February 11, 2013

SAFETY RECALL NOTICE – SAYFLINK SLEEVE **Immediate Action Required**

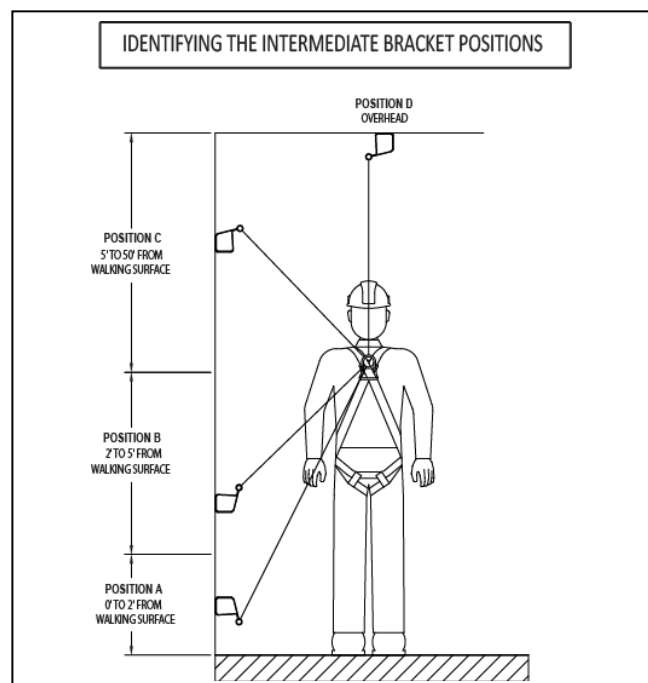
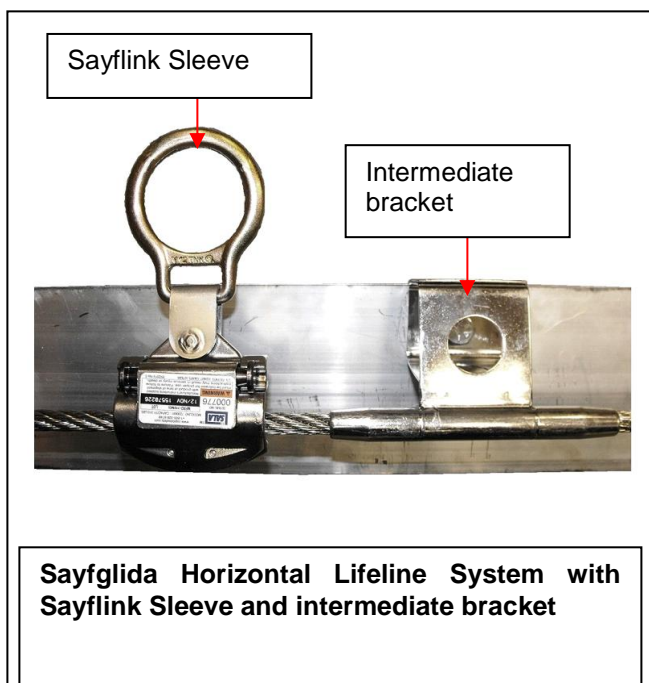
The reason for the recall is that, when the intermediate brackets are installed at walking surface level (between zero and two feet above the walking surface as illustrated in Position A below), there is a remote possibility that the sleeve can disengage from the cable as it slides over an intermediate bracket while trailing a worker moving across the walking surface. See “Identifying the Intermediate Bracket Positions” below.

Although Capital Safety's testing shows the Sayflink Sleeve is safe to use in bracket positions B, C and D as illustrated above (and any height between these positions), out of an abundance of caution, Capital Safety is recalling all Sayflink Sleeves regardless of the height of the permanently installed brackets.

If you have Sayflink Sleeves in service that were manufactured after May 2004, you should immediately take the sleeves out of service and call our Customer Service department at 1-800-387-7484 to arrange to return the sleeve. Capital Safety will repair or replace the sleeve dependent upon the specific needs of the end user. This will be done at Capital Safety's expense. The free replacement applies only if the returned sleeve is in proper working condition as determined by Capital Safety; if not, charges may apply.

Alternative fall protection must be used pending receipt of the upgraded sleeve. We recommend twin-leg lanyards to maintain 100% tie-off during use of the Sayfglida System.
